Addendum No: 3  
Date: March 3, 2025  
Owner: Northern Health  
Stantec # 144320012

This addendum is to be read with and constitutes part of the tender document.

UHN - Cardiac Diagnostic Services - Phase 3

Title  
DOOR SCHEDULES & MOUNTING ELEVATION

Project No. 144320012  
Revision D  
Scale AS NOTED  
Drawing No. A-002

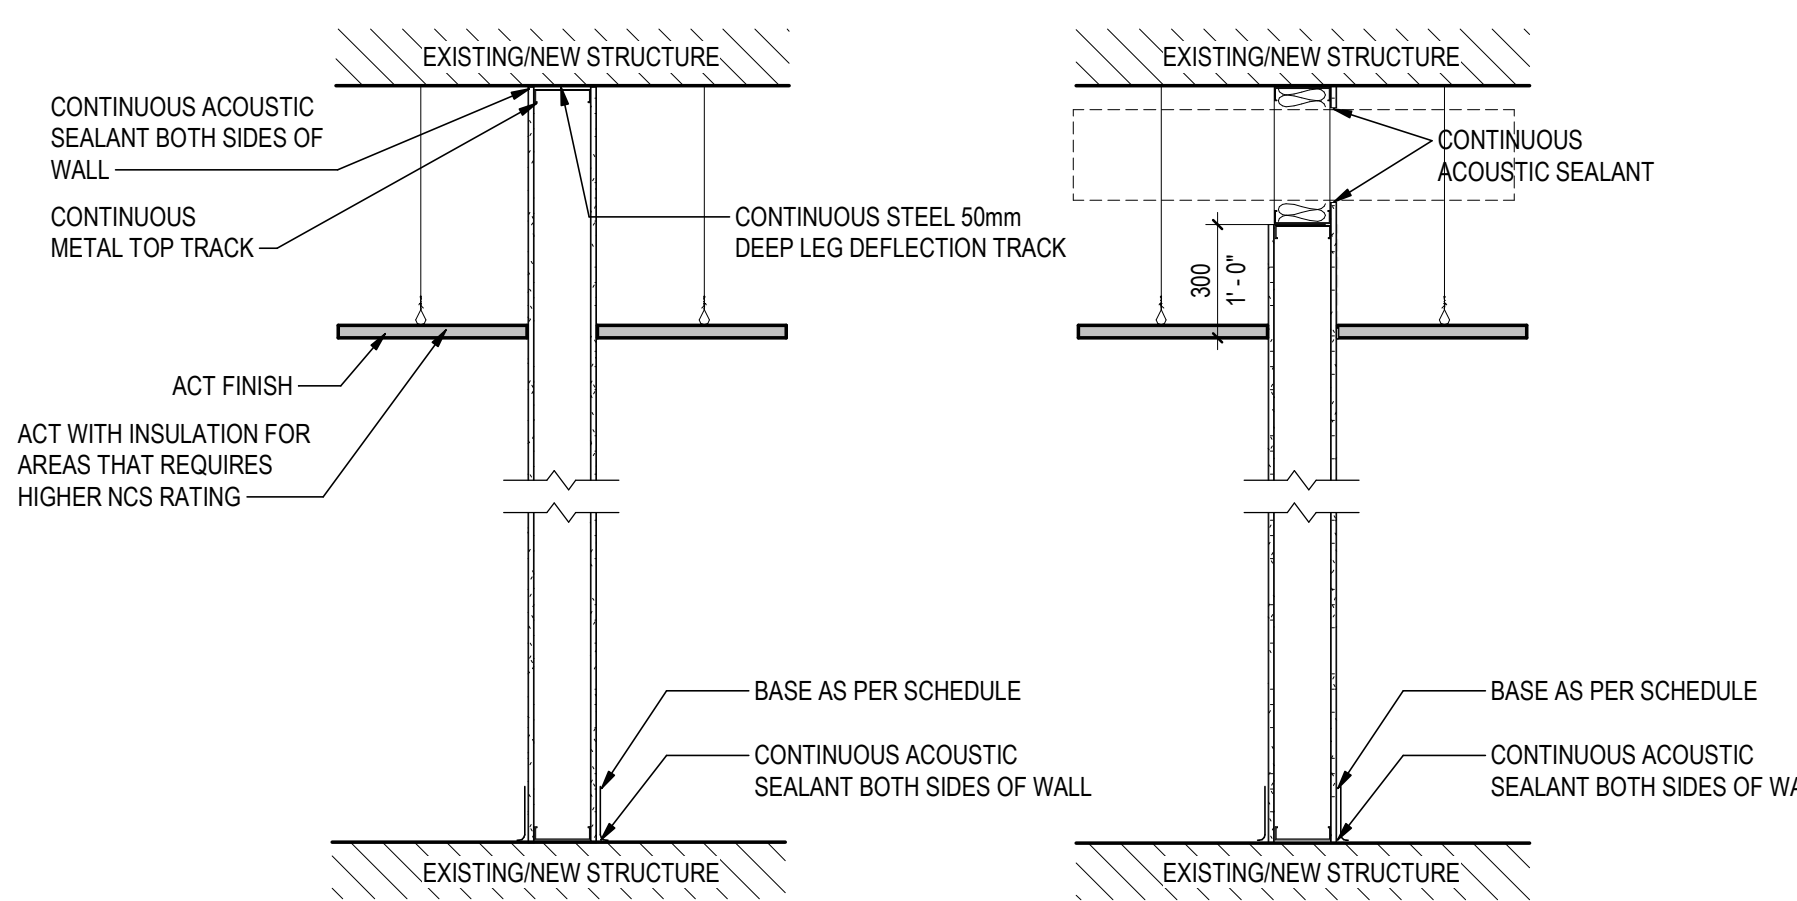
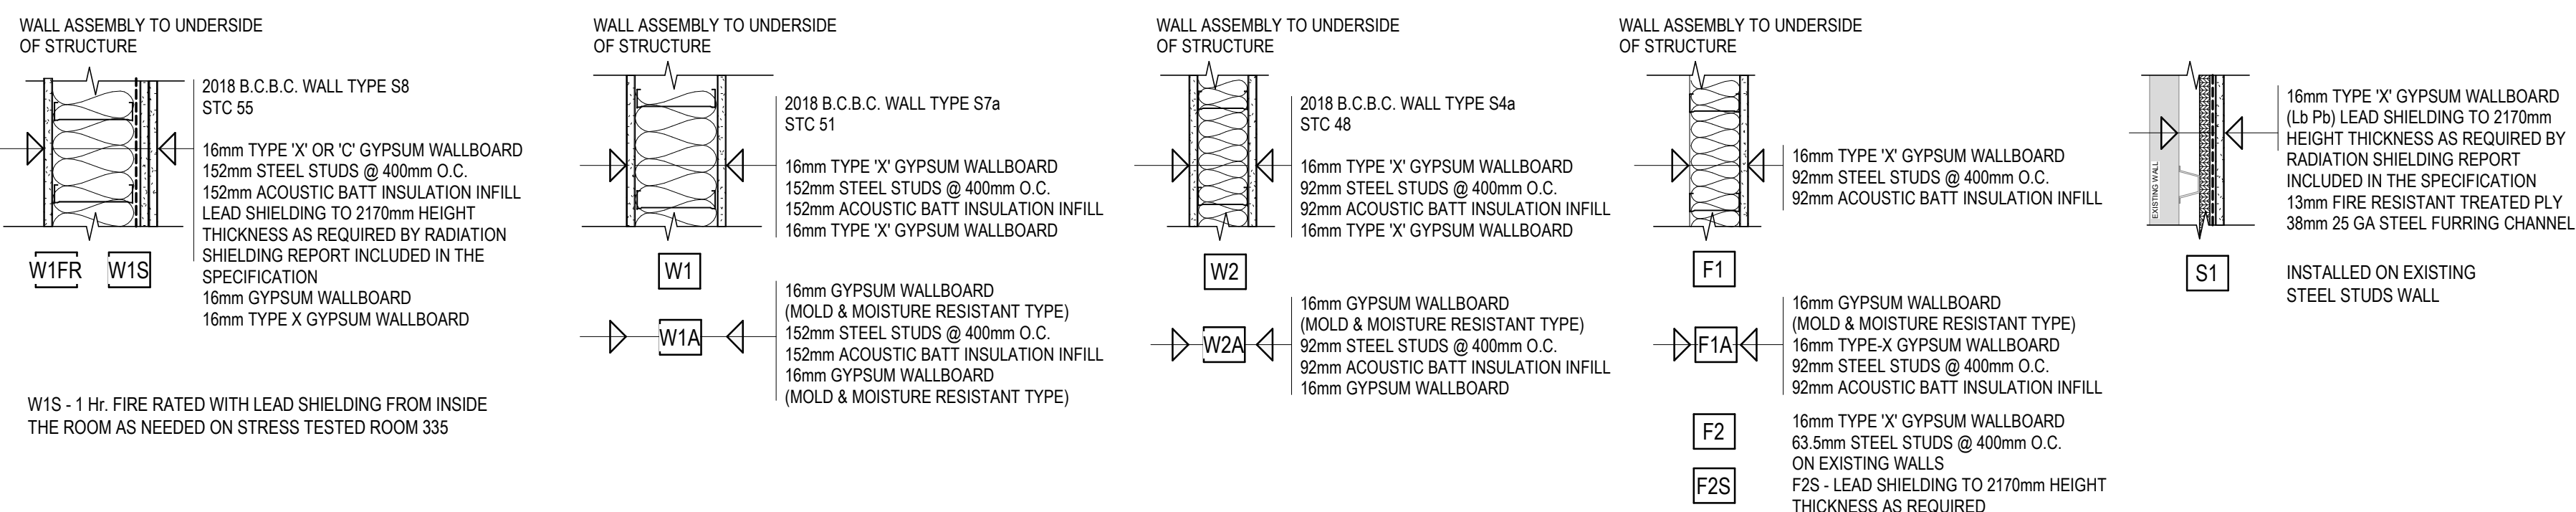
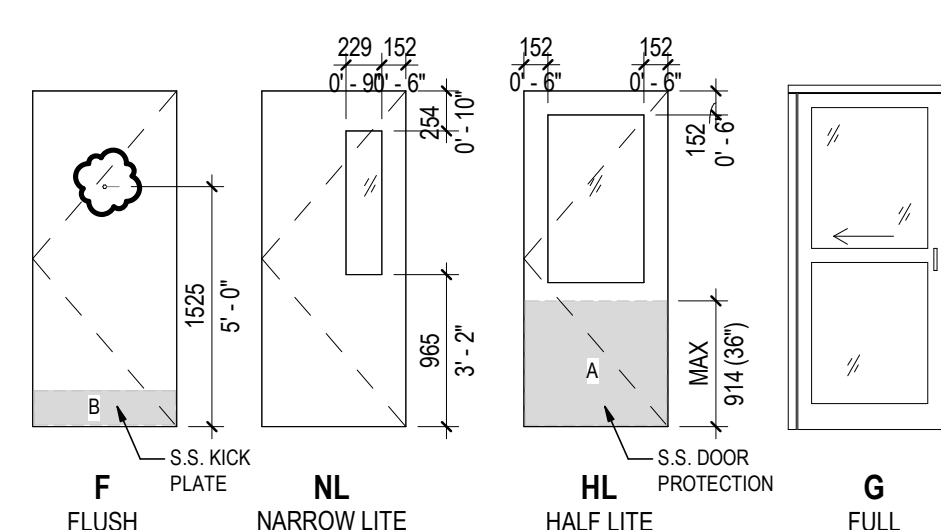
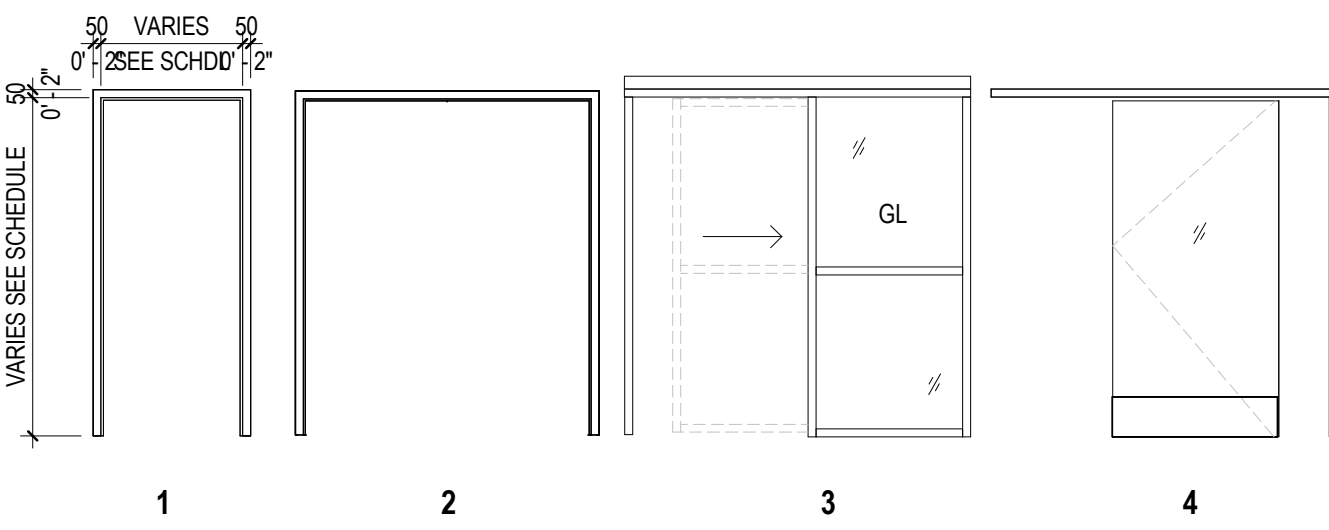
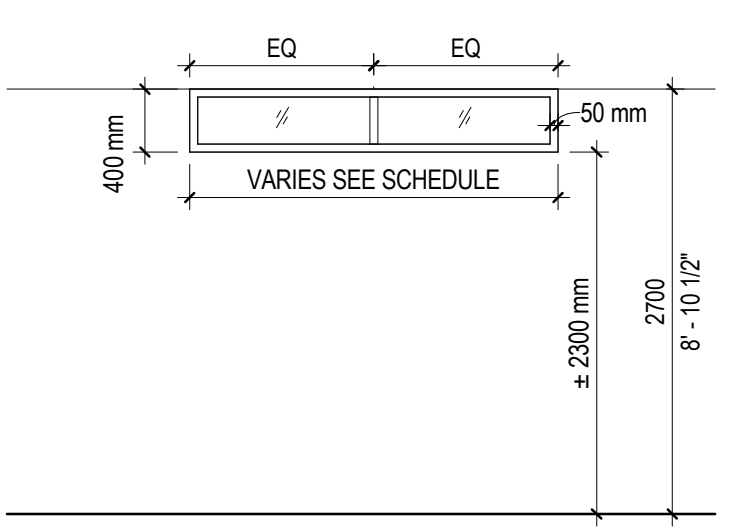
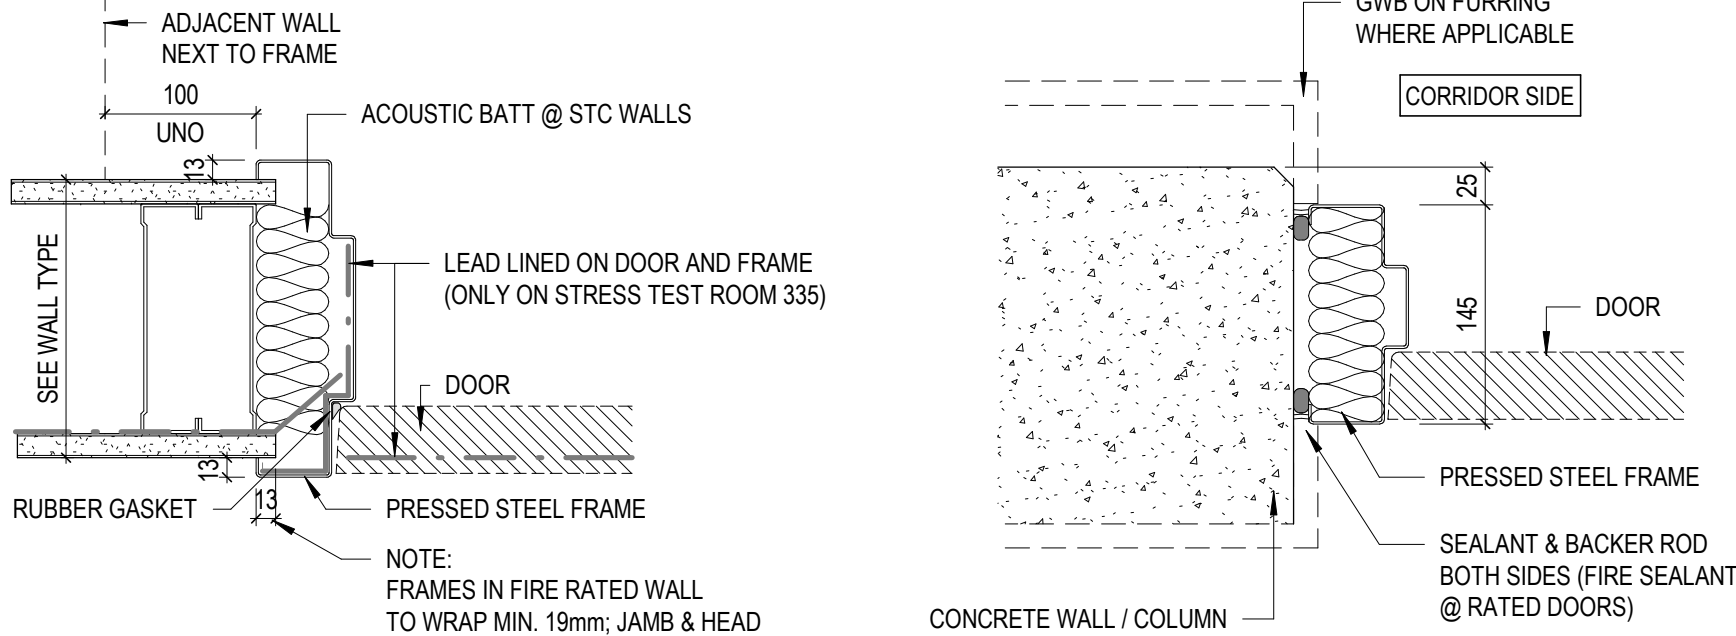
A-002 Door schedule hardware group updated

Q: 1. Door Schedule calls for N351 to have Automatic Operator, Touchless Sensors, Internal Lock Button. Hardware Group No. 015 does not list any of the above hardware. Please advise if new Hardware Group No. 015 will be released including ADO, Sensors, Internal Lock Button and any additional components required?

2. Door Schedule calls for E343, E389 & E1508 “Existing Door Equipped With ADO”. These doors are listed as Hardware Group No. 001 which calls for new Armor Plates only. Please advise if the ADO’s on the existing doors are existing or are they new? If new ADO’s please advise if new Hardware Group No. 001 will be released including ADO, Actuators, and any additional components required?

Door Schedule says N334 “Equipt with peep hole” but Hardware Group No. 002 does not have a door viewer or peep hole.

- A:
1. Door N351 updated to group 009.
  2. Door E343 updated to group 001. Doors E389, E1508 updated to group 001A
  3. See updated group 011 Auto operator, with hands free sensor, model CM-7536VR/4

4. See updated group 002, Viewer Schlage 180/200-degree view angle, metal brass, finish satin chrome plate.
